**Report of the U.S. Nuclear Regulatory Commission  
Expert Evaluation Team on Concerns Pertaining to  
Gas Transmission Lines Near the Indian Point Nuclear Power Plant**

**April 8, 2020**

## Executive Summary

Figure 12. Sketch prepared by NRC analyst in conducting sensitivity study for PRB on 3-minute isolation valve closure time for AIM pipeline.

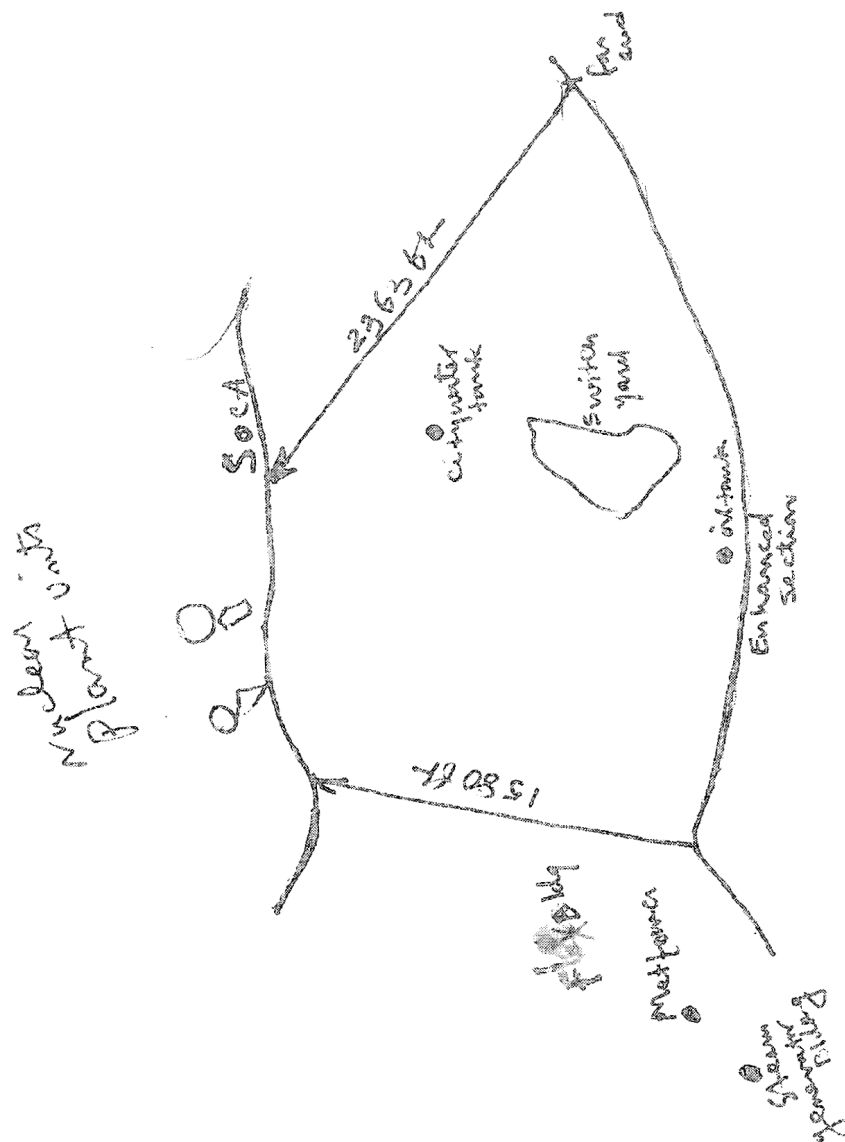
<sup>101</sup> A security-related summary of this analysis is available to the NRC staff at ADAMS Accession No. ML15078A067. Images of portions of the analysis are included in this report as Figure 12 and Figure 13.

distance to SOCA from enhanced section of pipeline = 1580ft

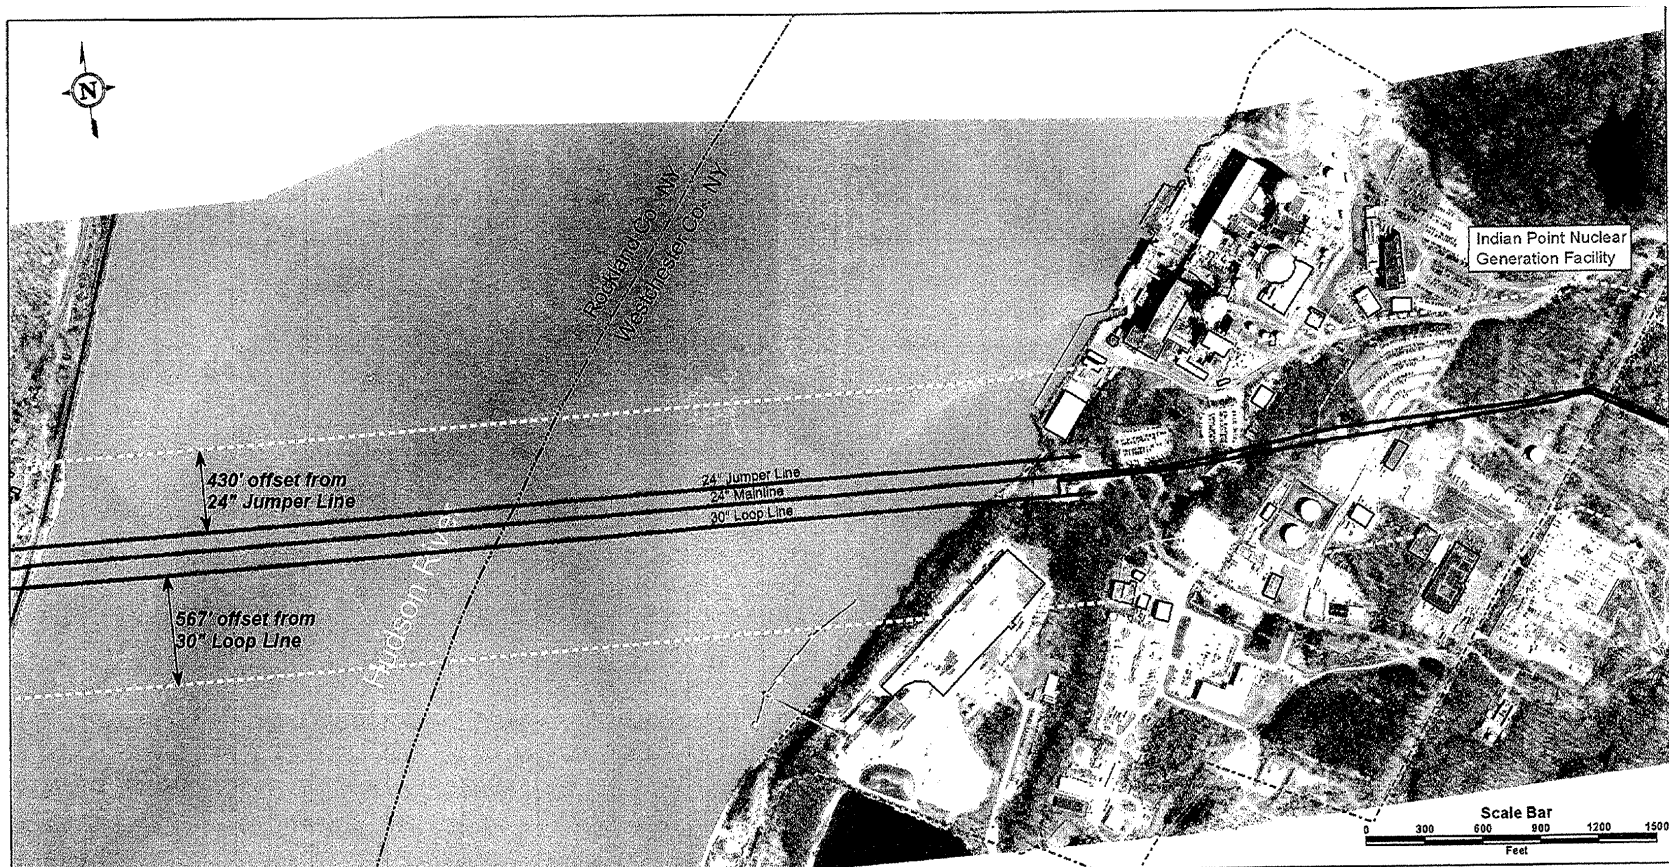
This revision changed the diameter of the pipeline, added the figure included in this report as Figure 20, and clarified Entergy’s ability to determine activities within the easements to ensure safe operation of the units.
